IN THE DRAWINGS

Applicants have attached replacement drawing sheets illustrating amended FIG.

3. Text in the boxes of FIG.3 has been amended as follows:

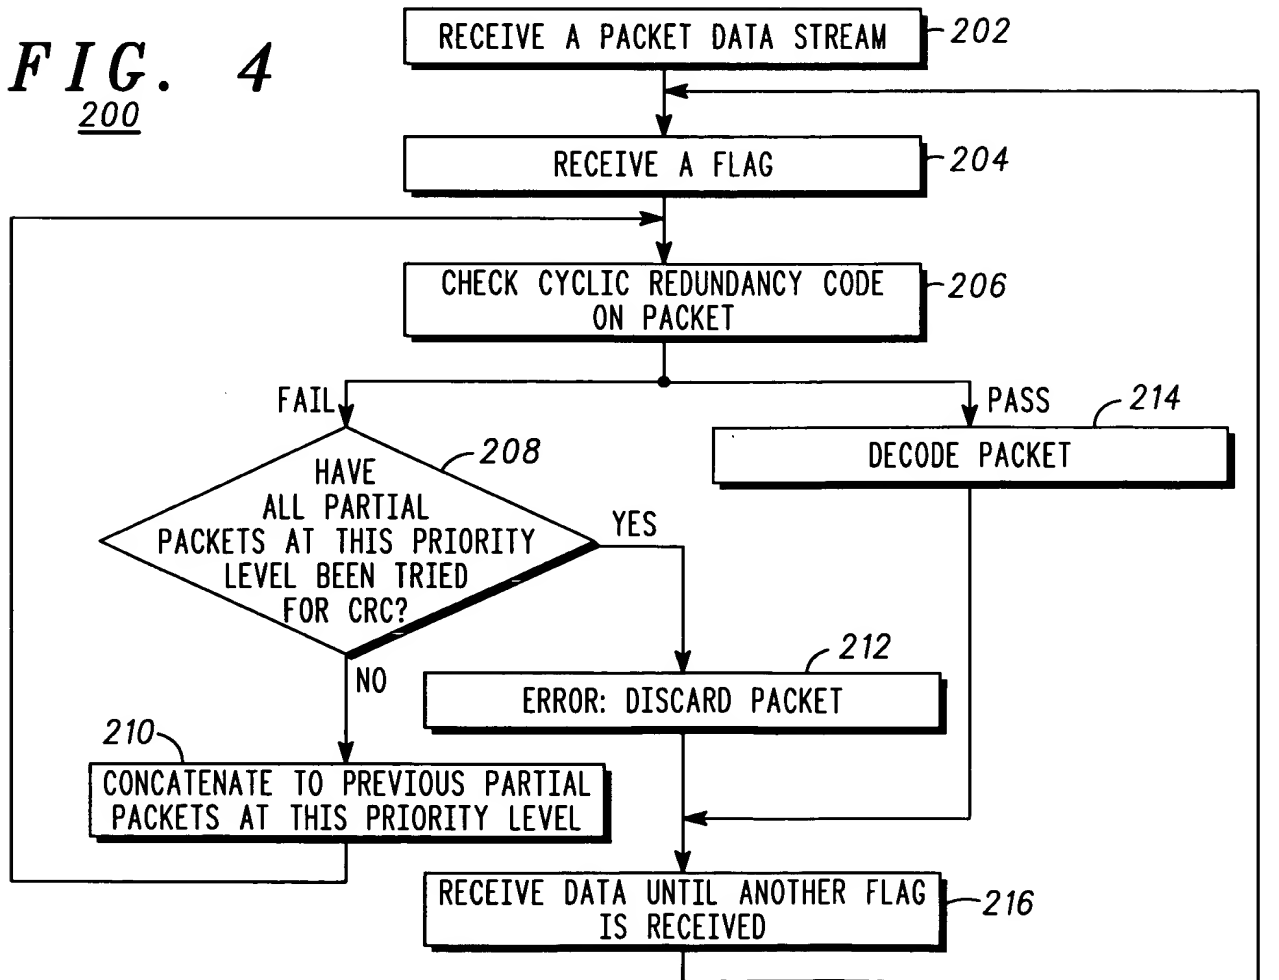
In box 102, "PACKETS" has been amended to read "PACKET";

In box 104, "TIME CRITICAL" has been deleted and ", IS DETERMINED TO BE TIME CRITICAL," has been inserted after "PACKET SHOWS UP";

In boxes 108 and 112, "REMAINDER" has been amended to read "REMAINING PORTION"; and

In box 110, "AFTER FLAGGING THE PACKET HEADER OF THE NON-TIME CRITICAL PACKET, " has been inserted before "TRANSMIT".
